Subject: Response to the Referenced Information Request, Waste Isolation Pilot Plant
Hazardous Waste Facility Permit Number: NM4890139088-TSDF

Reference: New Mexico Environment Department Correspondence from John E. Kieling, Chief,
Hazardous Waste Bureau to Todd Shrader, Carlsbad Field Office and Bruce C.
Covert, Nuclear Waste Partnership LLC, dated January 25, 2019, subject:
Information Request, Determination of Class for New Shaft and Associated
Connecting Drifts Waste Isolation Pilot Plant EPA I.D. Number NM4890139088

Response to NMED Information Request, Determination of Class for a Permit Modification Request for the Excavation of a New Shaft and Associated Connecting Drifts

Figure A2-9c (with correction)
Underground Ventilation System Airflow (with S#5)

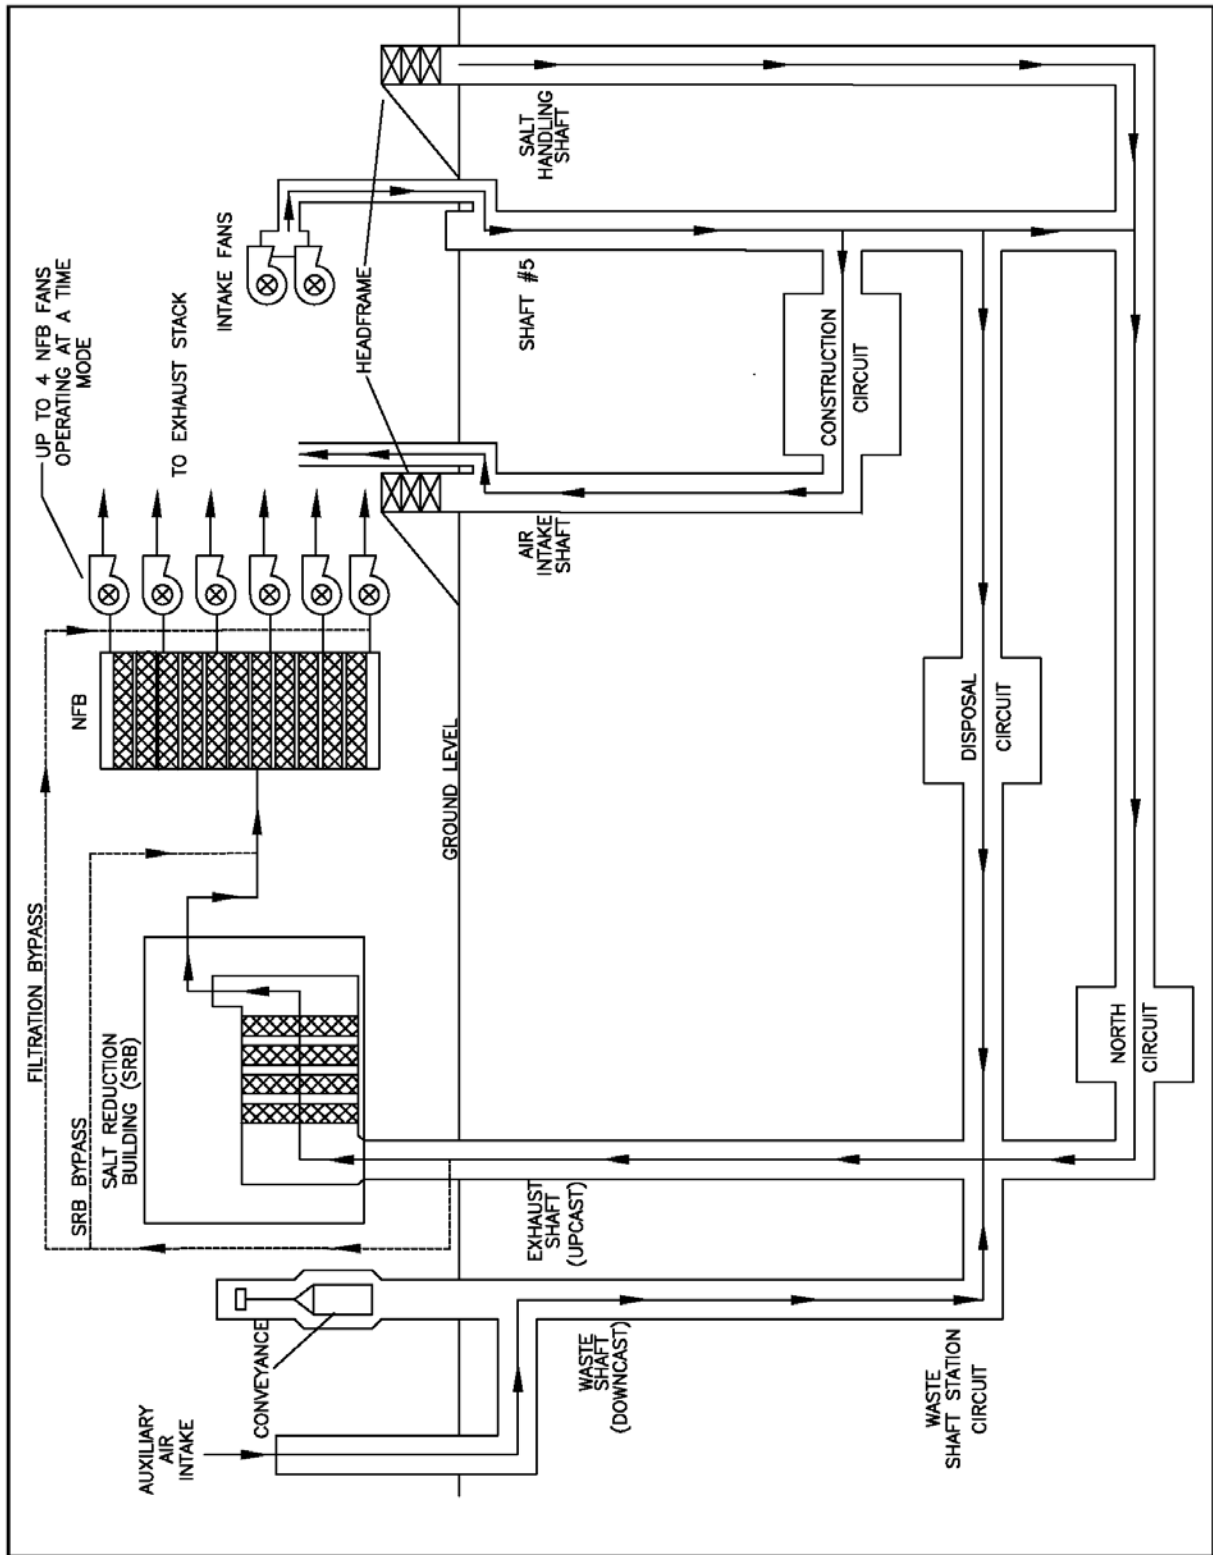
A change to the proposed Permit text that will be made is the correction of a “cut and paste” error in proposed Figure A2-9c, *Underground Ventilation System Airflow (with S#5)*. The corrected figure is attached to this document.
